NEBRASKA CAPITOL ENVIRONS COMMISSION STAFF REPORT

APPLICATION NUMBER Urban Design Record #24058
APPLICATION TYPE Certificate of Appropriateness (update)
ADDRESS/LOCATION 225 S 16th Street
HEARING DATE April 26, 2024
ADDITIONAL MEETINGS February 25, 2022, July 28, 2023 and January 26, 2024
APPLICANT Drew Sova, 402-408-0005, dsova@whitelotusgroup.com
STAFF CONTACT Collin Christopher, 402-441-6370, cchristopher@lincoln.ne.gov

Mural Mixed-Use Project Rooftop Screening Review

Centennial Mall and M Street- 5' Screen

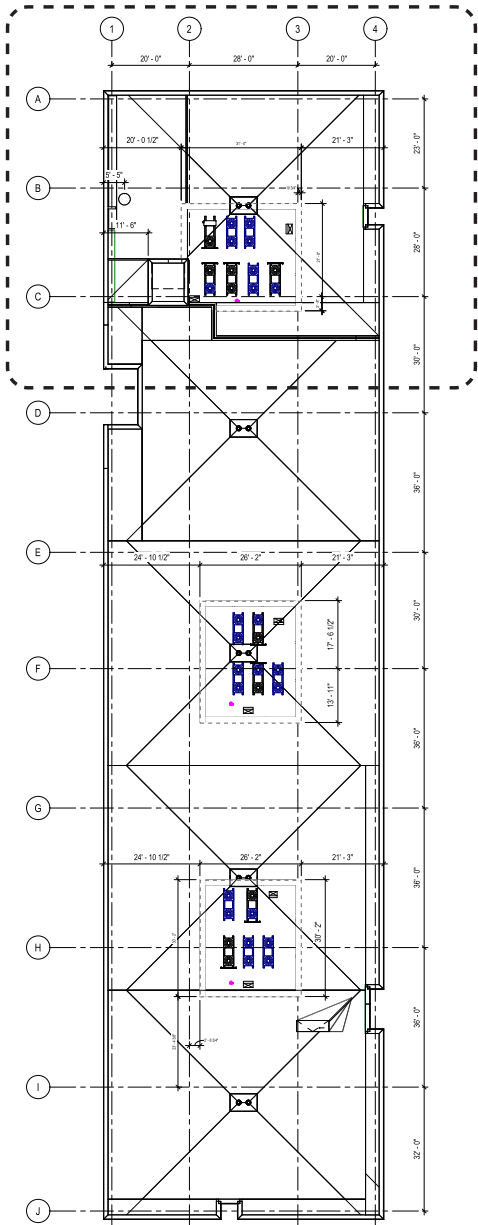
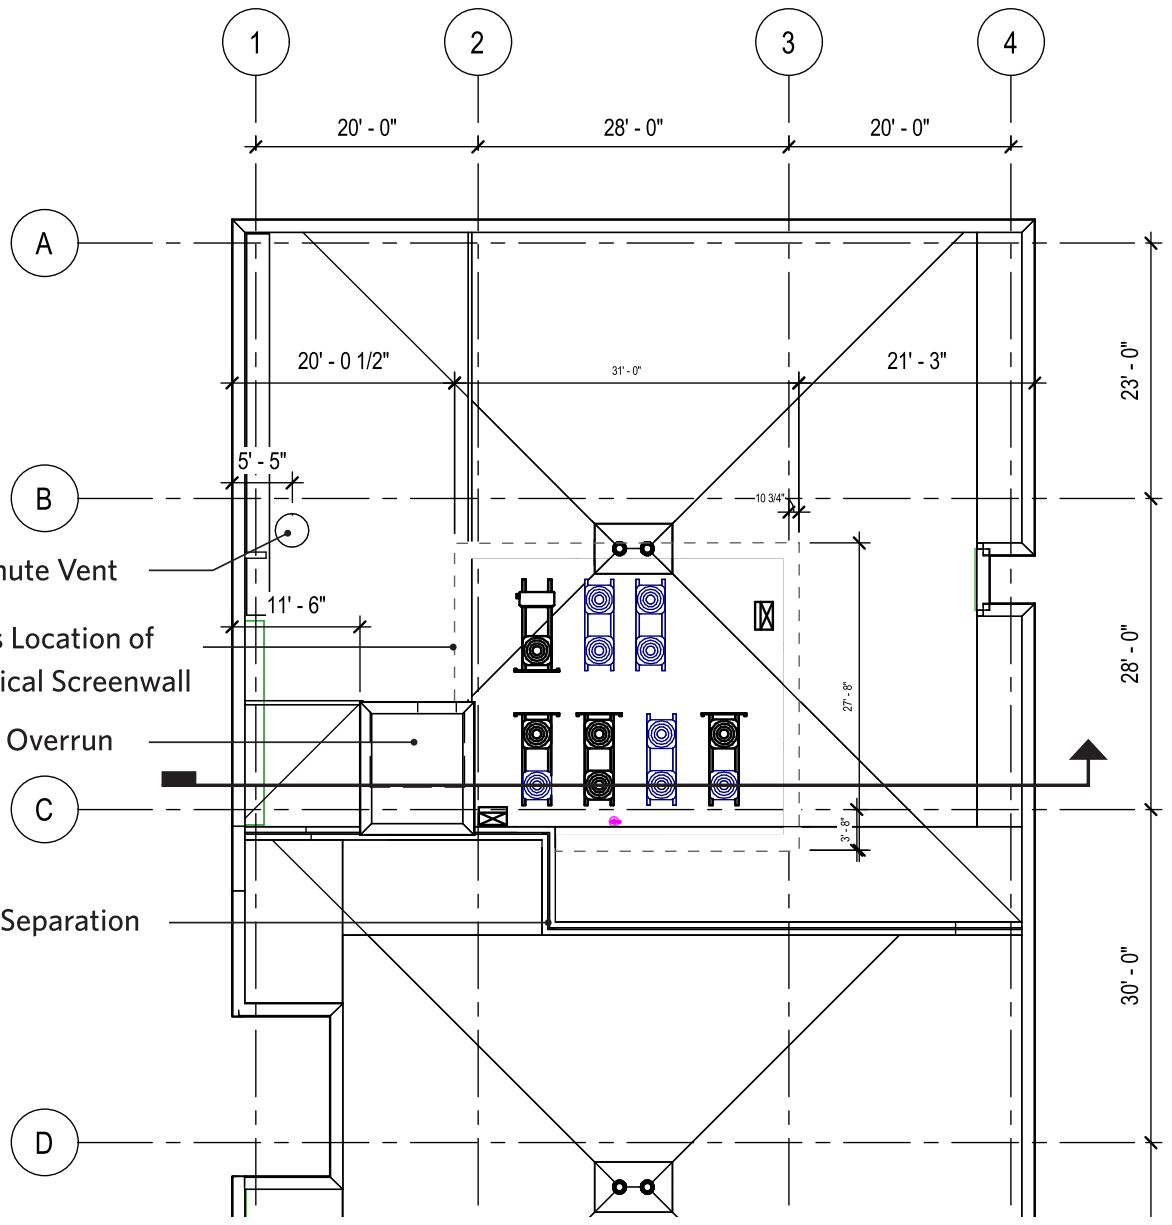
Centennial Mall and M Street - No Screen

Proposed Roof Plan - Area A

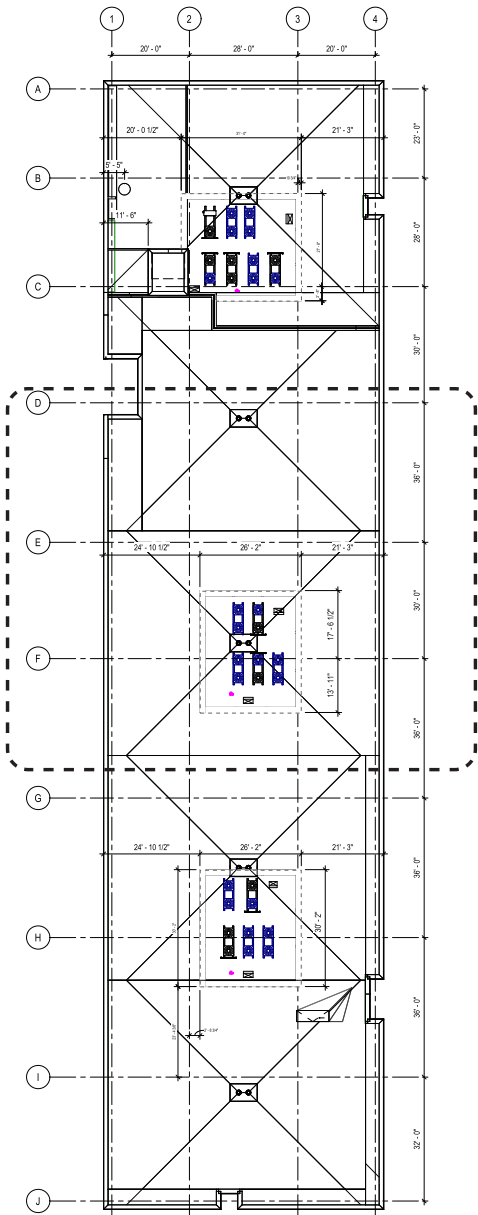
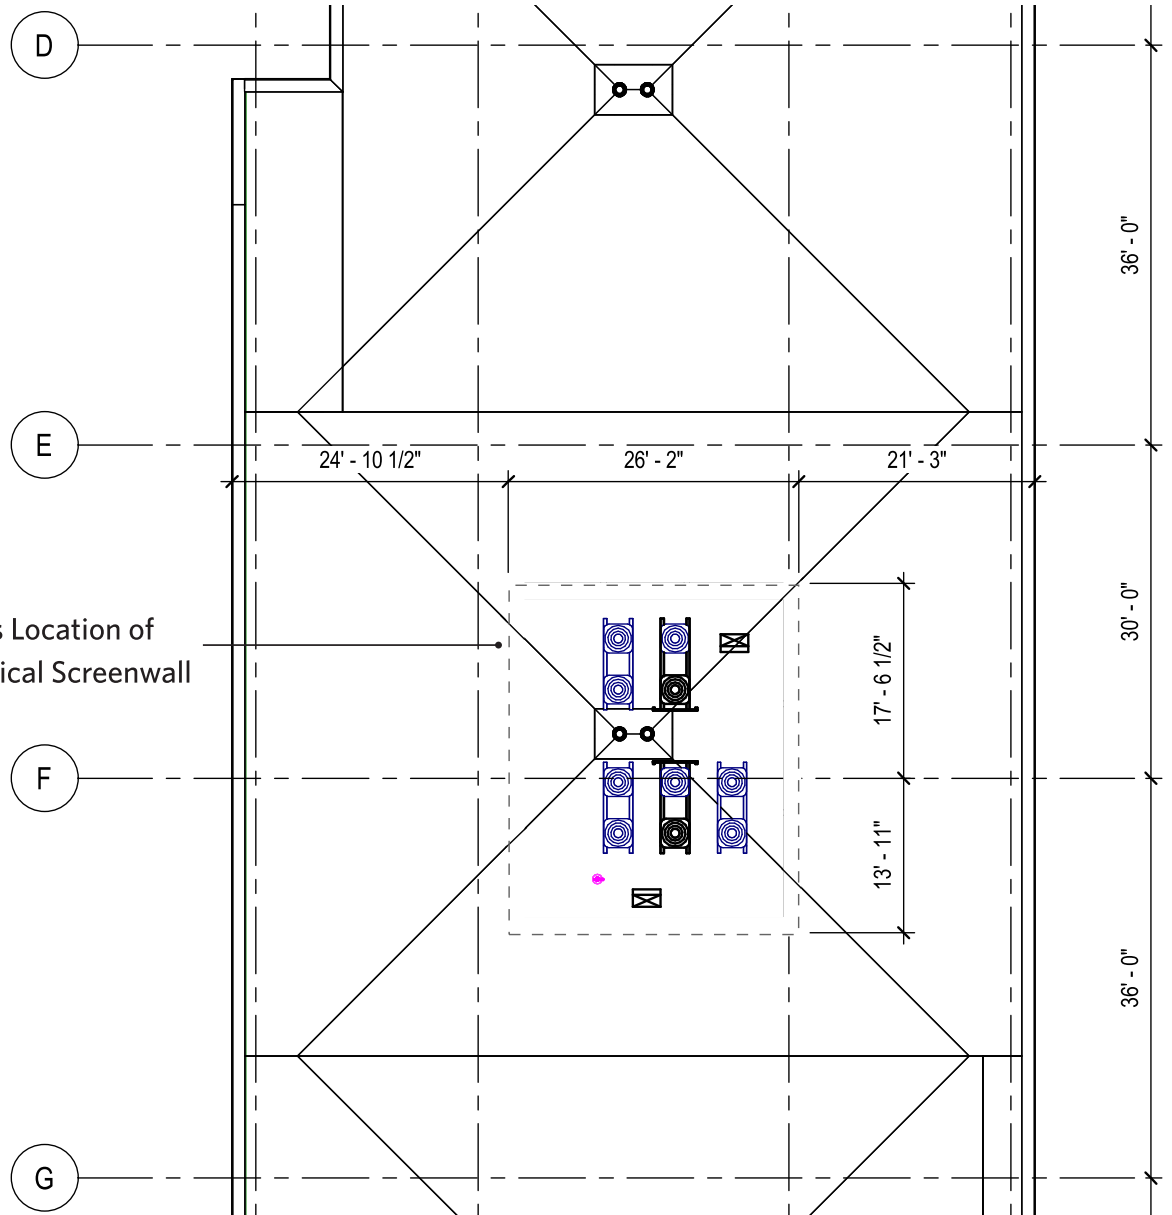
As the applicant moves closer to construction, they are now requesting to remove the previously approved rooftop screening from the project for budgetary reasons. There are no other changes being requested at this time.

- Trash Chute Vent
- Previous Location of Mechanical Screenwall
- Elevator Overrun
- Firewall Separation

Recommended finding: The revised submittal that proposes the removal of rooftop equipment screening generally complies with the Capitol Environs Design Standards.

Proposed Roof Plan - Area B

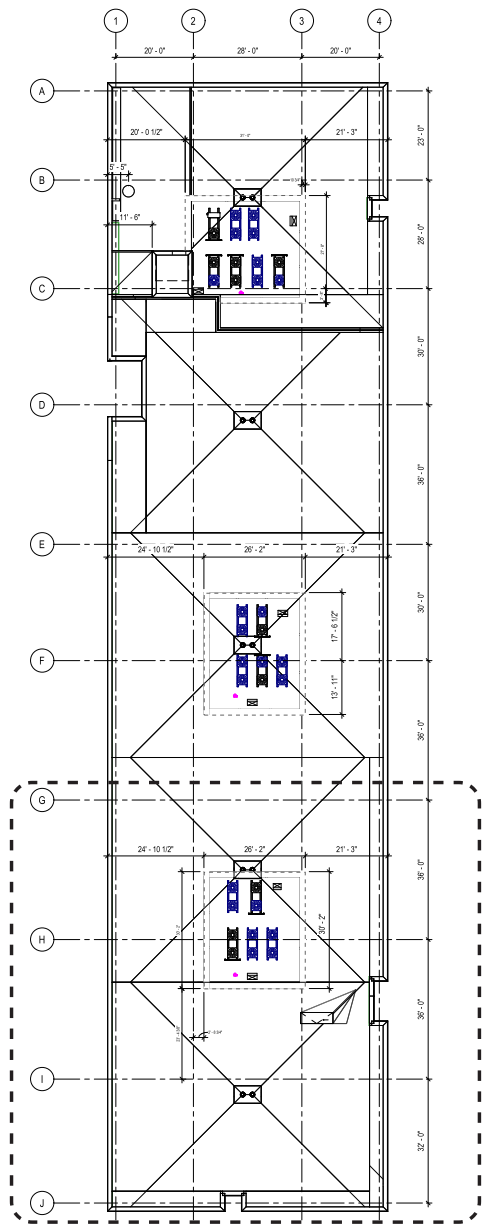
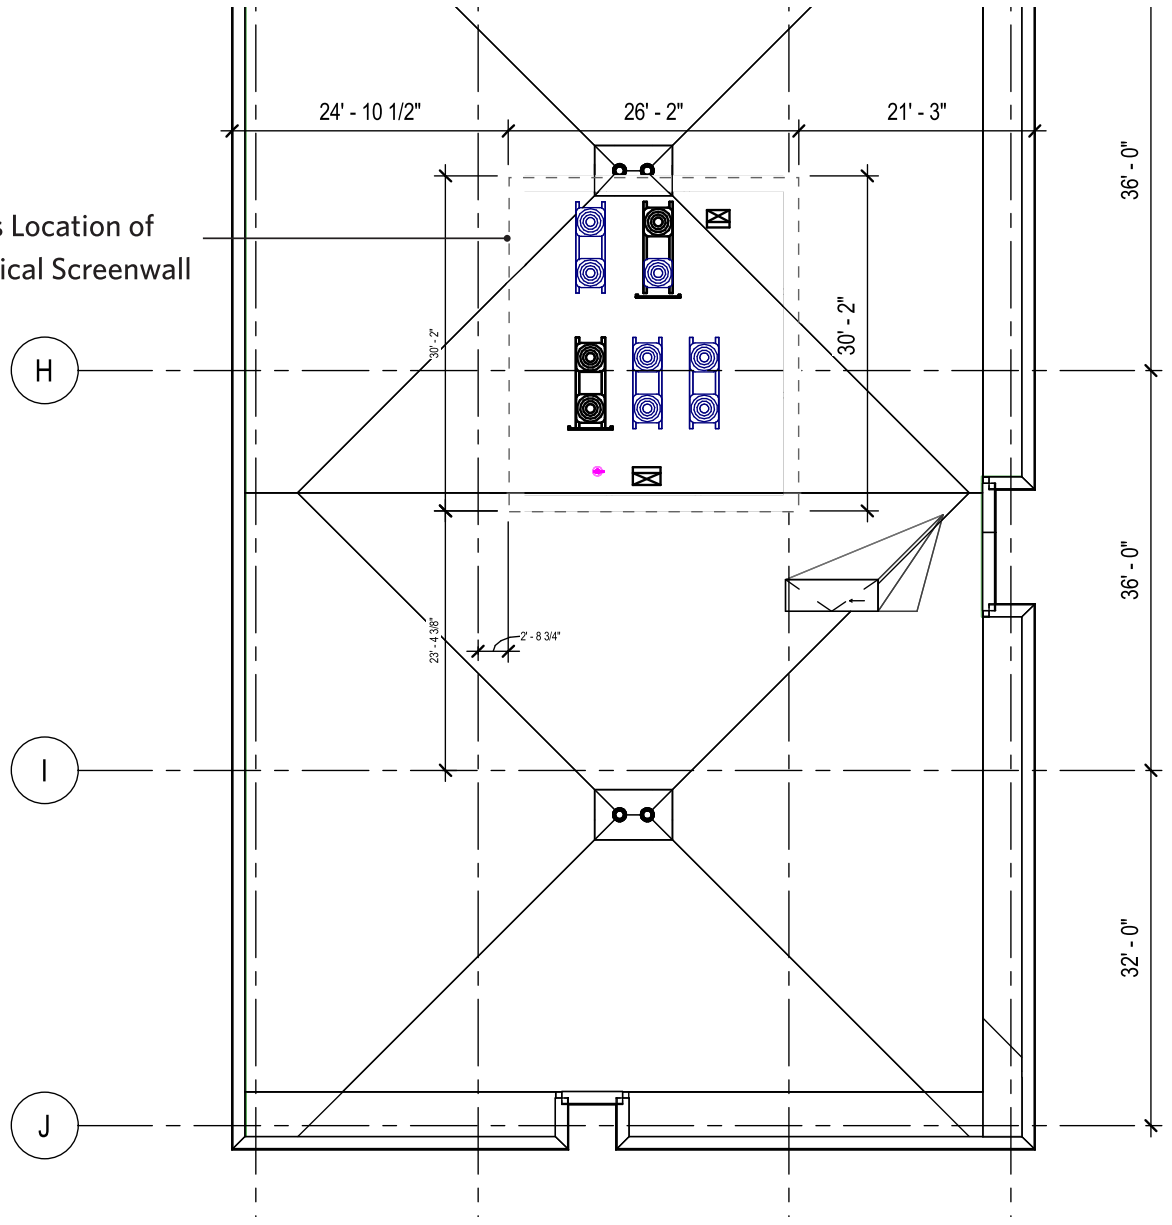
Previous Location of Mechanical Screenwall
